**SERVICE  
BULLETIN**

**mazda**

# 1984 Service Bulletin Book

SUBJECT Eccentric Shaft Pulley Modification.

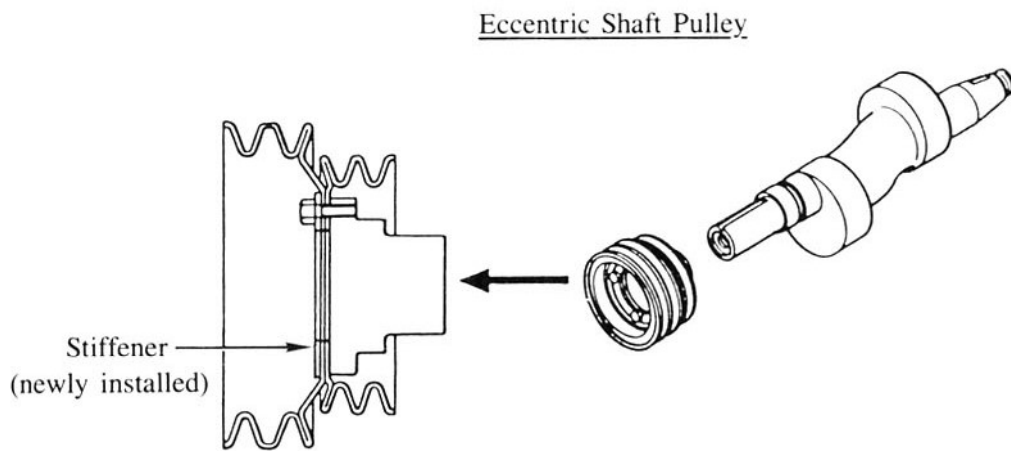
DESCRIPTION A stiffener has been installed on the eccentric shaft pulley since the production date of August, 1984.

PART NUMBER		DESCRIPTION	INTERCHANGEABILITY	APPLIED MODEL
NEW	OLD			
N249 11 600A	N249 11 600	Eccentric Shaft Pulley	NEW → OLD	RX-7 12A
N304 11 600A	N304 11 600	Eccentric Shaft Pulley	NEW → OLD	RX-7 13B

SUBJECT Intake Manifold Gasket.

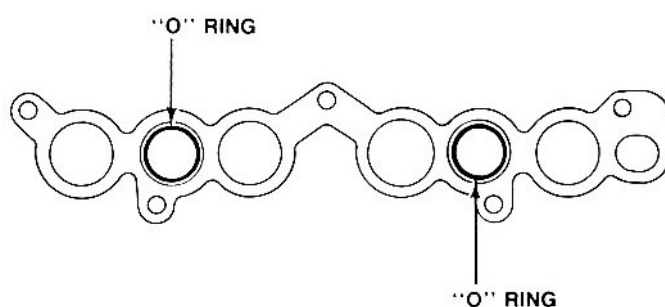
DESCRIPTION The material of intake manifold gasket for 1981 and 1982 GLC has been changed for better sealing along with inserting two (2) "O" rings onto the gasket.

The part number for newly established is E508 23 799.

Please note that the "O" rings may be detached from the gasket easily if you bend it. Handle the gasket with care and make certain the "O" rings are in place prior to installing the intake manifold.

SUBJECT Secondary Air Control System Modification.

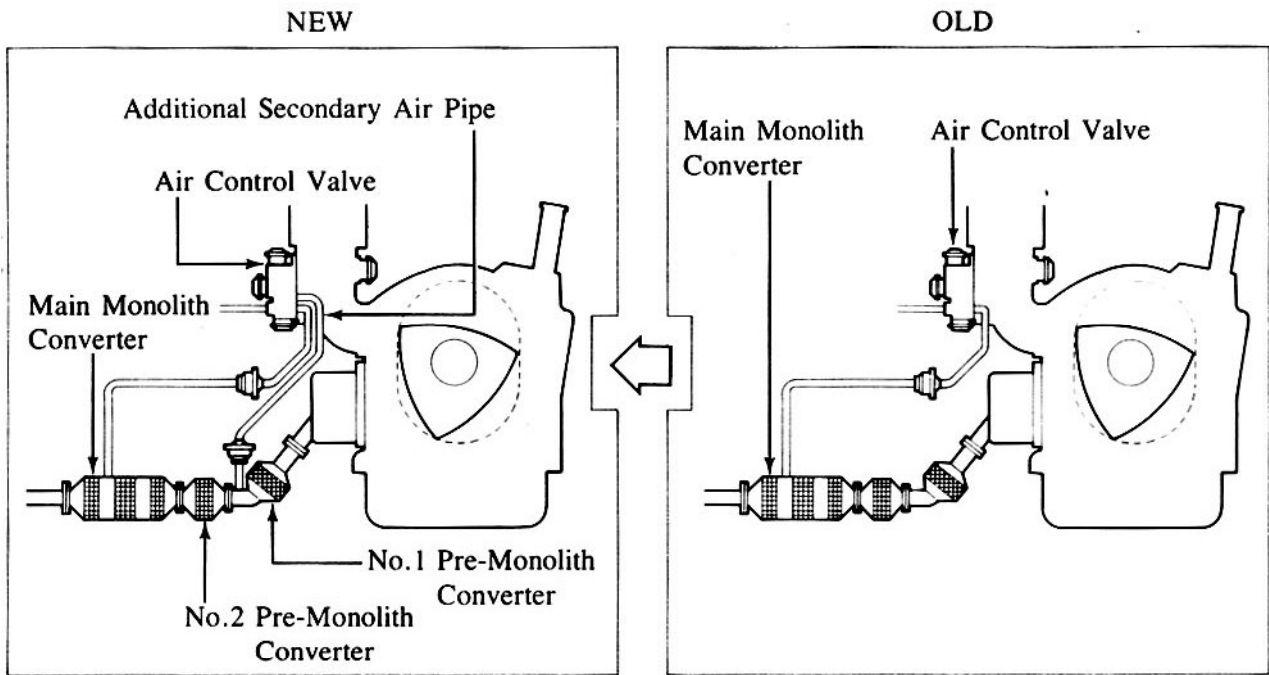
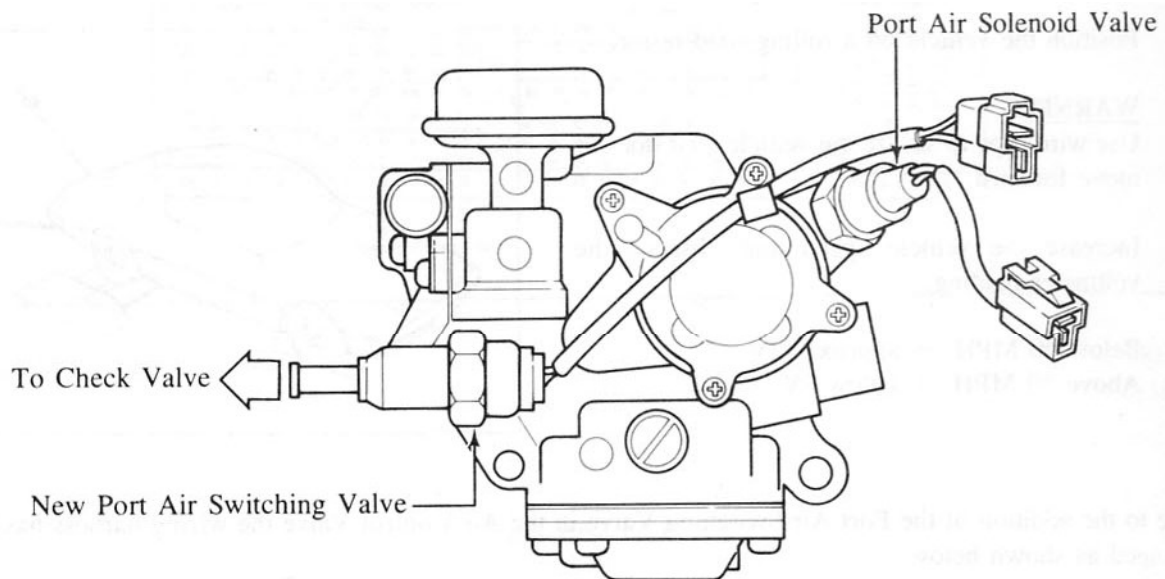
DESCRIPTION The Secondary Air Control System has been modified since the production date of March, 1984.

Now air is injected behind the No.1 pre-monolith converter when the Port Air Switching Valve (newly added to the Air Control Valve) is open. Port and split air operation remain the same as previous years.

The Port Air Switching Valve will open between 3,000-4,000 rpm or above 50 mph.

PART NUMBER		DESCRIPTION	QTY	INTERCHANGEABILITY	APPLIED MODEL
NEW	OLD				
N249 13 720B	N249 13 720A	Air Control Valve	1	NO	M/T (Federal)
N250 13 720A	N250 13 720	Air Control Valve	1	NO	A/T (Federal)
N251 13 720B	N251 13 720A	Air Control Valve	1	NO	M/T (California)
N252 13 720A	N252 13 720	Air Control Valve	1	NO	A/T (California)
N249 18 941D	N249 18 941C	Control Unit	1	NEW → OLD	M/T
N250 18 941C	N250 18 941B	Control Unit	1	NEW → OLD	A/T
N249 18 051F	N249 18 051E	Engine Wiring	1	NEW → OLD	
N250 20 725	-	Solenoid Valve	1	NO	
N249 40 718	-	Air Hose	1	NO	
N249 40 720	-	Air Pipe	1	NO	
N249 40 780C	N249 40 780B	No.1 Pre-Converter	1	NO	
N304 40 814E	N304 40 814D	Protector	1	NEW → OLD	M/T
N250 40 814E	N250 40 814D	Protector	1	NEW → OLD	A/T
FA54 67 010K	FA54 67 010J	Front Harness	1	NEW → OLD

Newly Established

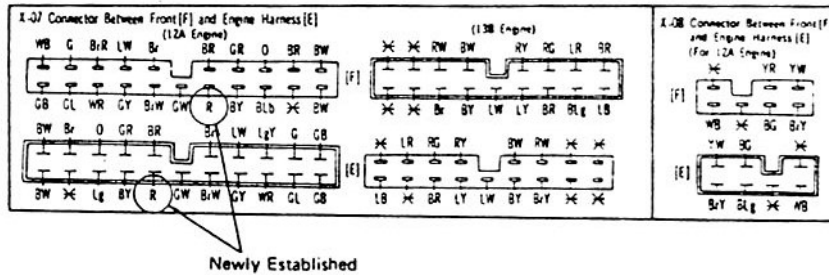
Due to the addition of the Port Air Switching Valve in the Air Control Valve the wiring harness has been changed as shown below.

**SUBJECT** Modification of Bearing Cover Bolts.

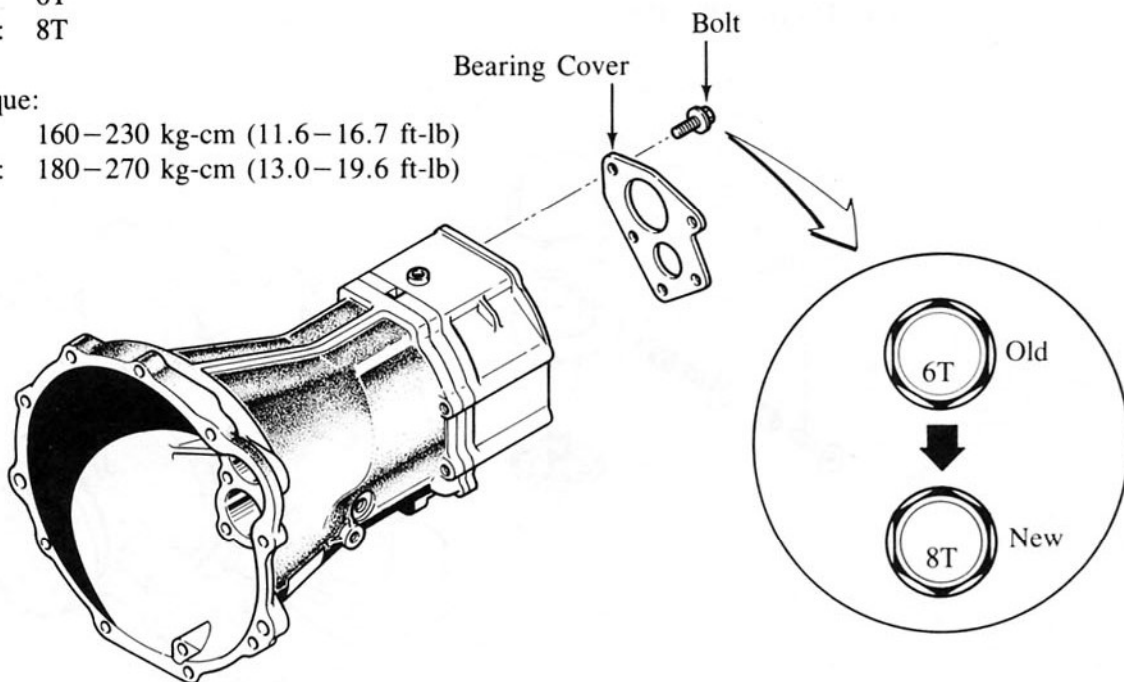
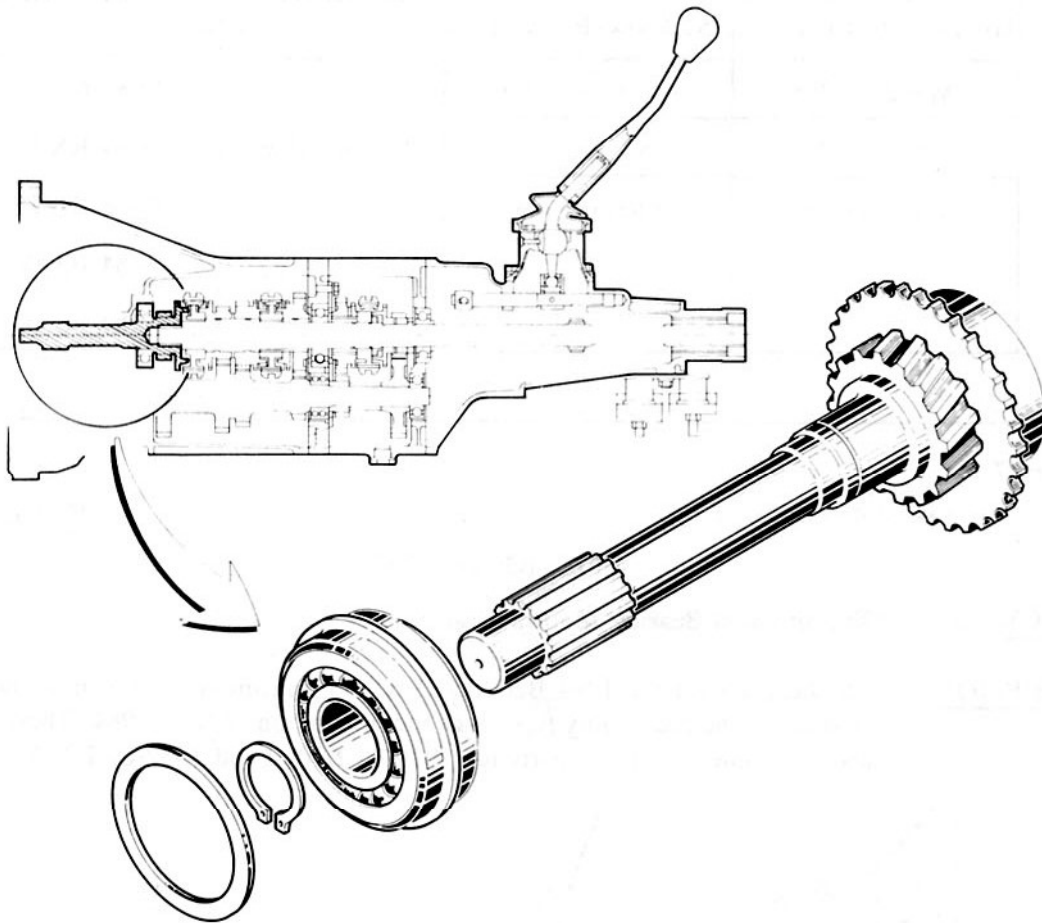
**DESCRIPTION** The bolts attaching the transmission bearing cover have been strengthened and the tightening torque has been increased to improve the durability of the transmission.

Identification mark on the bolt head:

Old: 6T  
New: 8T

Old: 160–230 kg-cm (11.6–16.7 ft-lb)  
New: 180–270 kg-cm (13.0–19.6 ft-lb)

PART NUMBER		DESCRIPTION	QTY	INTERCHANGEABILITY
NEW	OLD			
9078 12 820	9080 12 820	Bolt	5	NEW → OLD

SUBJECT Transmission Bearing Modification.

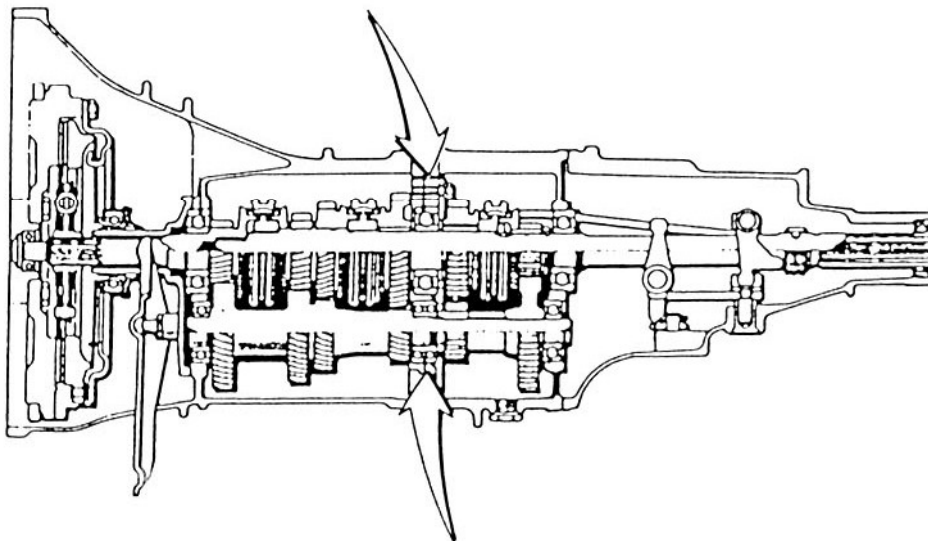
DESCRIPTION The bearings for the 1984 B2000 and B2200 transmission, shown below, have been changed to the heavy duty type since the production of July, 1984. These bearings are also available as service parts for 1979-84 B2000 and 1982-84 B2200.

SUBJECT 5th Gear & Counter 5th Gear Modification.

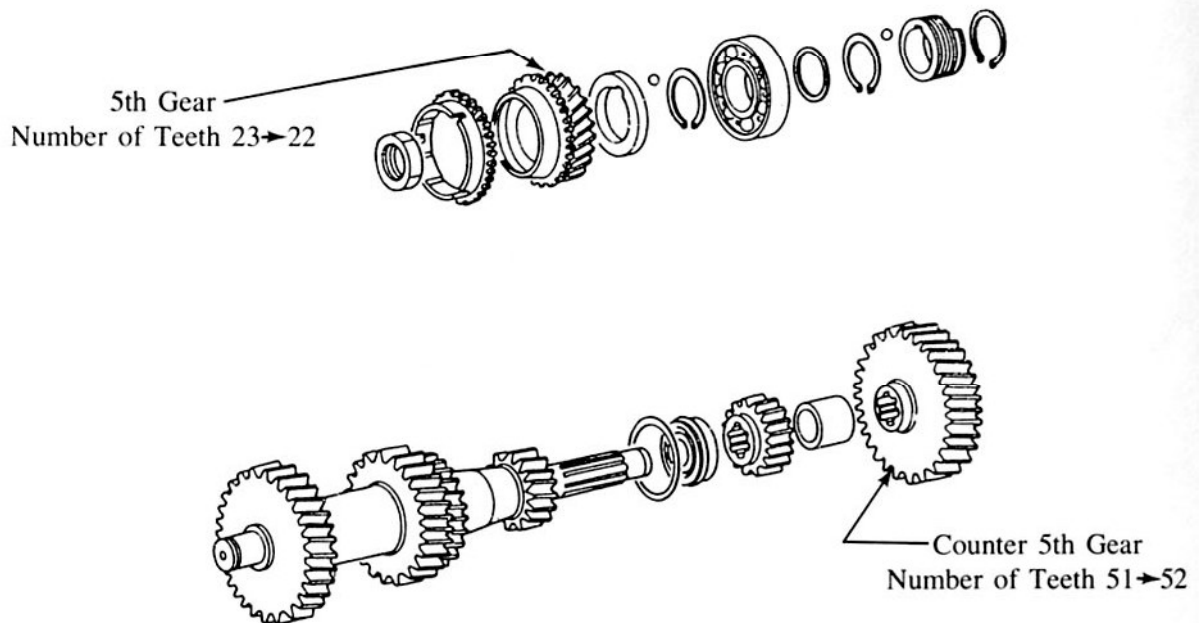
DESCRIPTION The number of the teeth of the 5th gear and counter 5th gear has been changed since the production date of July, 1984. Because of this change, the gear ratio of the 5th gear has been changed from 0.758 to 0.711.

PART NUMBER		DESCRIPTION	INTERCHANGEABILITY
NEW	OLD		
M504 17 308	M502 17 308A	Counter 5th Gear	NO
M509 17 611	M510 17 611	5th Gear	NO

1984 RX-7

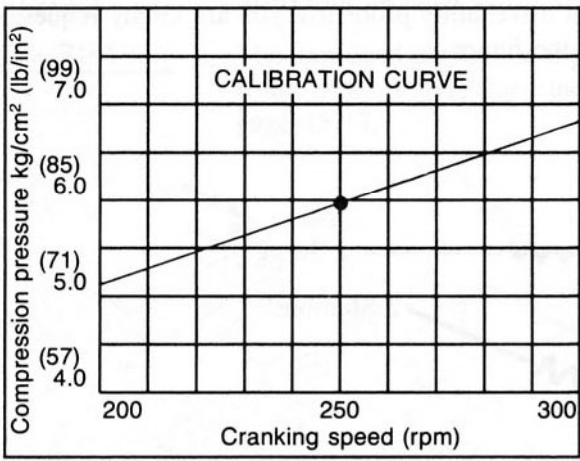
DESCRIPTION Please make the following corrections to the 1984-1985 RX-7 Workshop Manuals, page 1-12. Self-adhering stickers are provided for your convenience.

CORRECT	INCORRECT																																								
 <table border="1" style="width: 100%; margin-top: 10px; border-collapse: collapse;"> <tr> <td style="text-align: center;">Peaks</td> <td style="text-align: center;">17</td> <td style="text-align: center;">18</td> <td style="text-align: center;">19</td> <td style="text-align: center;"><b>20</b></td> <td style="text-align: center;"><b>21</b></td> <td style="text-align: center;">22</td> <td style="text-align: center;">23</td> <td style="text-align: center;">24</td> <td style="text-align: center;">25</td> </tr> <tr> <td style="text-align: center;">rpm</td> <td style="text-align: center;">204</td> <td style="text-align: center;">216</td> <td style="text-align: center;">228</td> <td style="text-align: center;"><b>240</b></td> <td style="text-align: center;"><b>252</b></td> <td style="text-align: center;">264</td> <td style="text-align: center;">276</td> <td style="text-align: center;">288</td> <td style="text-align: center;">300</td> </tr> </table>	Peaks	17	18	19	<b>20</b>	<b>21</b>	22	23	24	25	rpm	204	216	228	<b>240</b>	<b>252</b>	264	276	288	300	<table border="1" style="width: 100%; margin-top: 10px; border-collapse: collapse;"> <tr> <td style="text-align: center;">Peaks</td> <td style="text-align: center;">17</td> <td style="text-align: center;">28</td> <td style="text-align: center;">29</td> <td style="text-align: center;"><b>20</b></td> <td style="text-align: center;"><b>21</b></td> <td style="text-align: center;">22</td> <td style="text-align: center;">23</td> <td style="text-align: center;">24</td> <td style="text-align: center;">25</td> </tr> <tr> <td style="text-align: center;">rpm</td> <td style="text-align: center;">204</td> <td style="text-align: center;">216</td> <td style="text-align: center;">228</td> <td style="text-align: center;"><b>240</b></td> <td style="text-align: center;"><b>252</b></td> <td style="text-align: center;">264</td> <td style="text-align: center;">276</td> <td style="text-align: center;">288</td> <td style="text-align: center;">300</td> </tr> </table>	Peaks	17	28	29	<b>20</b>	<b>21</b>	22	23	24	25	rpm	204	216	228	<b>240</b>	<b>252</b>	264	276	288	300

Fig.17

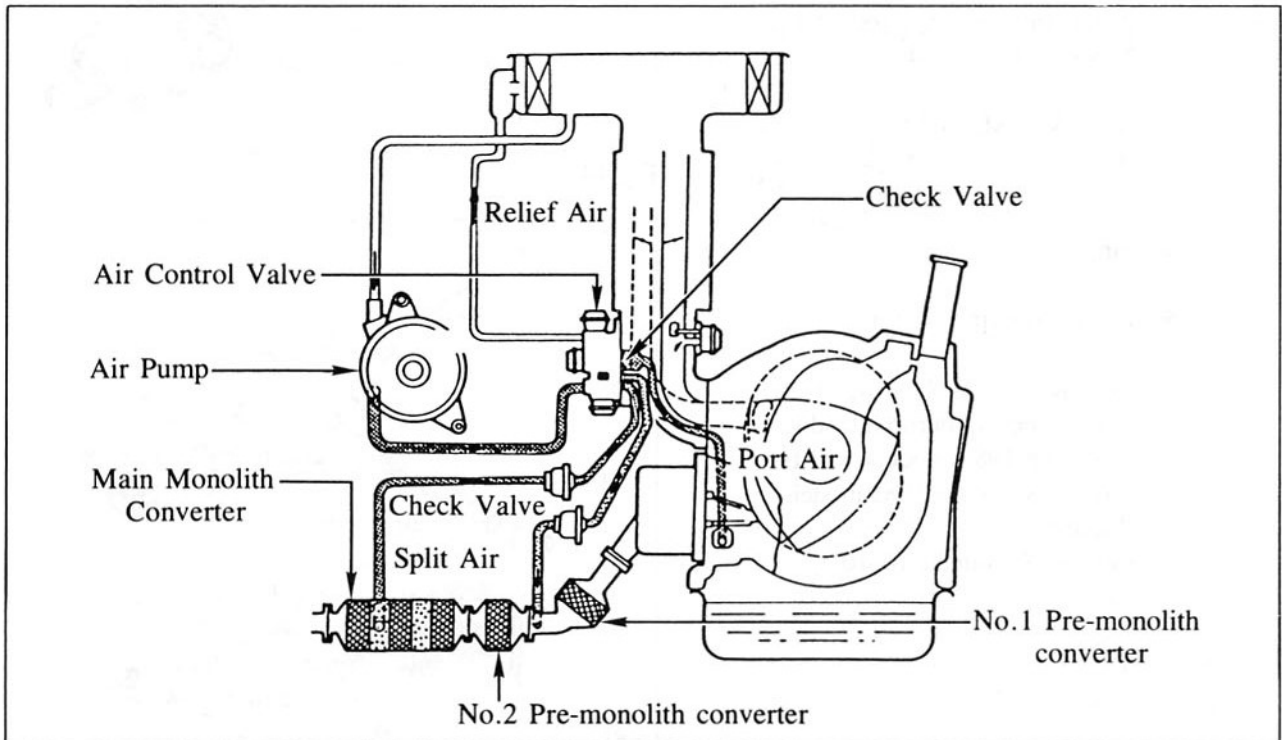
- Air Injection (Figure 17)

The port air switching valve introduced in mid-'84 has been carried over to the 1985 models.
